Doc Ref: WD898-04F01(rev0)- WE Memo

**RE: 24-26 RAILWAY PARADE, WESTMEAD
PEDESTRIAN WIND ENVIRONMENT MEMO**

Figure 1: Recommended In-Principle Treatments and Wind Speed Criteria for Level 1 F&B Precinct

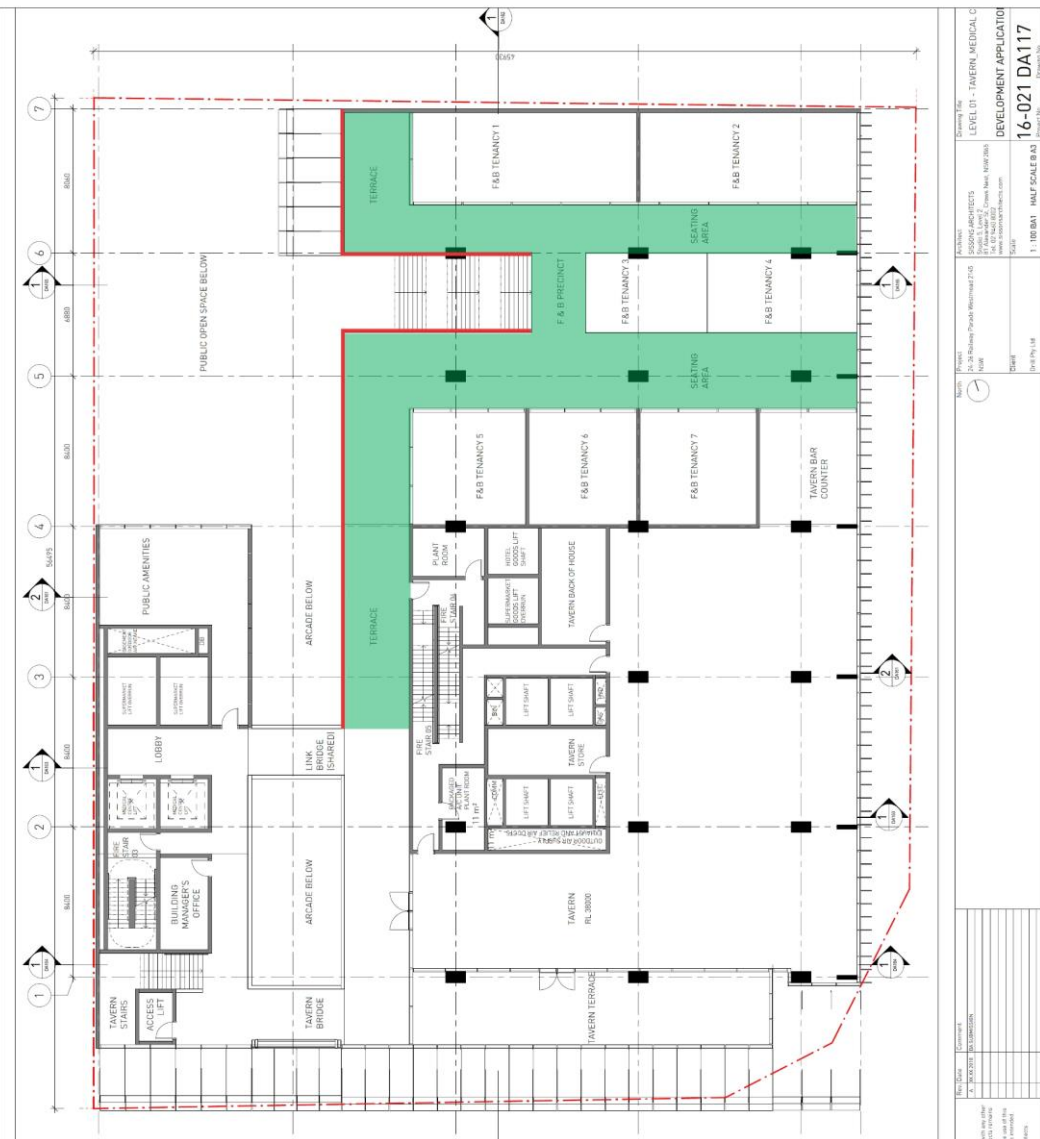
It should be noted that the prevailing westerly winds can directly impact the open terrace space on Level 1 and the public staircase access to Level 1. Furthermore, the designation of the open terrace space as an F&B precinct indicates that patrons will be seated in the terrace area for extended periods of time. It is, therefore, recommended that the impermeable balustrades be retained around the periphery of the open terrace space on Level 1, as indicated in Figure 1. The balustrades are expected to protect any patrons seated in the vicinity from adverse wind conditions. Furthermore, the proposed vegetation for the public open spaces will further improve the wind conditions around the staircase and Level 1 F&B precinct.

Retention of Impermeable Balustrade
